River Hamble Harbour Authority

Warsash Slipway

Report R.2115

Engineering Considerations

**Warsash Slipway Proposal
 (Plan View)**

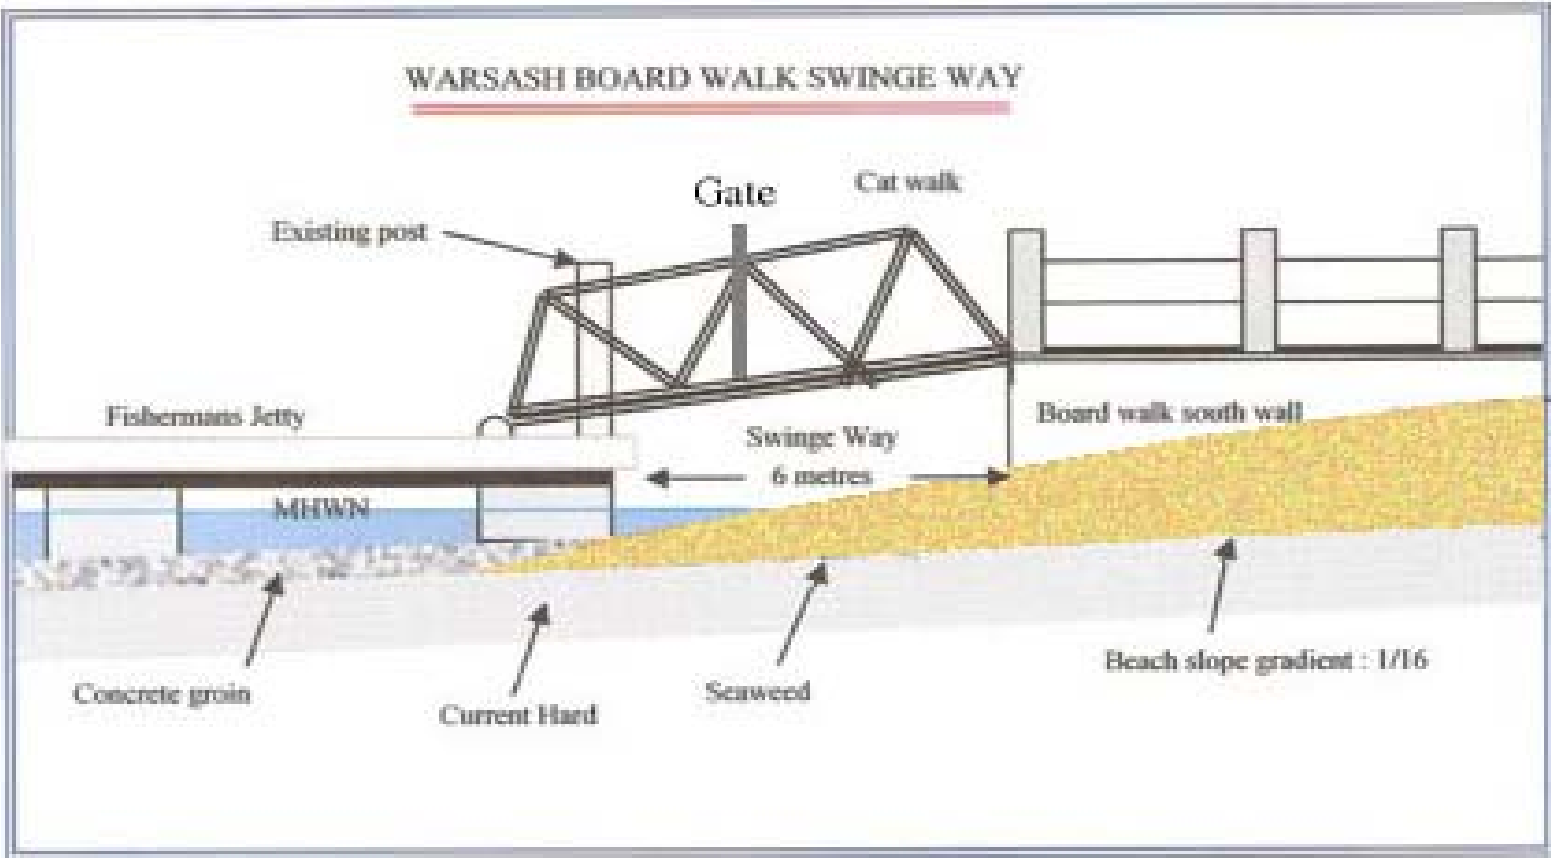
With dimensions extrapolated from the plan provided in Figure 2, the following approximate quantities in Table 2 have been calculated:

The proposed plan as shown in Figure 2 does not indicate the existing difference in level between the location of the gravel retaining board and the existing slipway as shown in Figure 1. If re-grading (levelling across the width) of the lower slipway is not required then the 100mm protrusion of the gravel retaining board to hold the 'Grasscrete' and new surface gravel will have no significant physical effect. The inclusion of marker posts will benefit the users of the slipway.
